PERMIT

SEWAGE DISPOSAL SYSTEM
HOWARD COUNTY HEALTH DEPARTMENT
BUREAU OF ENVIRONMENTAL HEALTH
410-313-2640

P 515034-B

SUBDIVISION Paternal Gift Farm

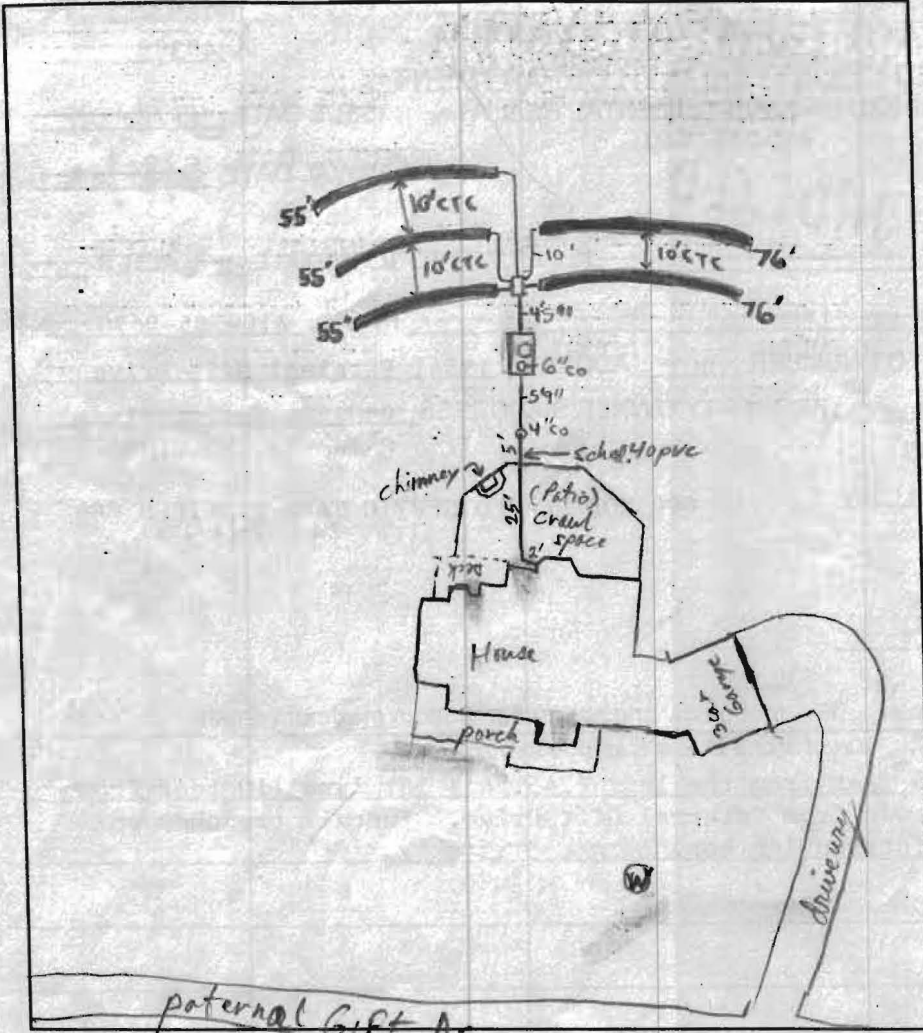
PRE-CONSTRUCTION INSPECTION: 5/21/01 - OK TO START - (5) 60-65' TRENCHES
IN BOTH DIRECTIONS; S.T. 10' FROM PATIO; OK TO REDUCE TOTAL TRENCH (MR)

INSPECTION COMMENTS: House connection under crawl space OK to cover. RYP 4/18/01

5/30/01 - OK TO COVER ALL WORK (SRK)
